Problem:

- A) The screen on the Insight Graphics Units (PFS1-G and PFS2-G) does not update, but the system continues to run.
- B) Message “Unable to communicate to Spindle Control Module” appears.
- C) Message “Communicating with SCM(s)” remains on the screen.

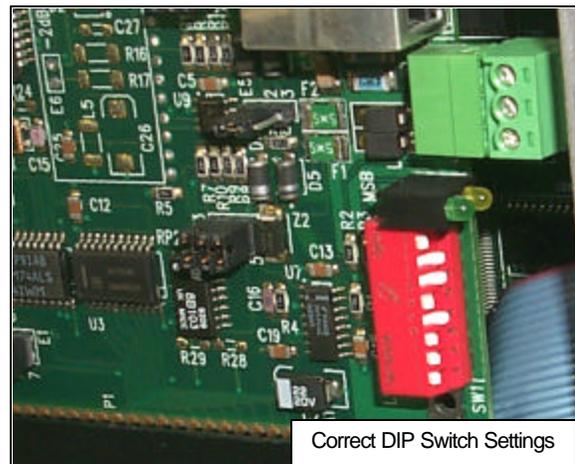
The ISA Extension Board that connects the Arcnet Board to the back of the Computer is not providing good continuity to all of the contacts. This could be because of thermal expansion, corrosion, or particle contamination.

Gold plated contacts are much less susceptible to contamination than the standard contacts used on the ISA extension board.

T21581-79 is the part number for the gold plated ISA Extension Board.

- 1) Turn off power to the Insight.
- 2) Remove plexiglass cover from the back of the PC Computer.
- 3) Remove the Arcnet Board (on the right with the red DIP switches and green connector).
- 4) Discard the old ISA Extension Board and replace with the gold-plated board.
- 5) Install the Arcnet board (make sure the DIP switch settings do not change).
- 6) Replace the plexiglass cover.
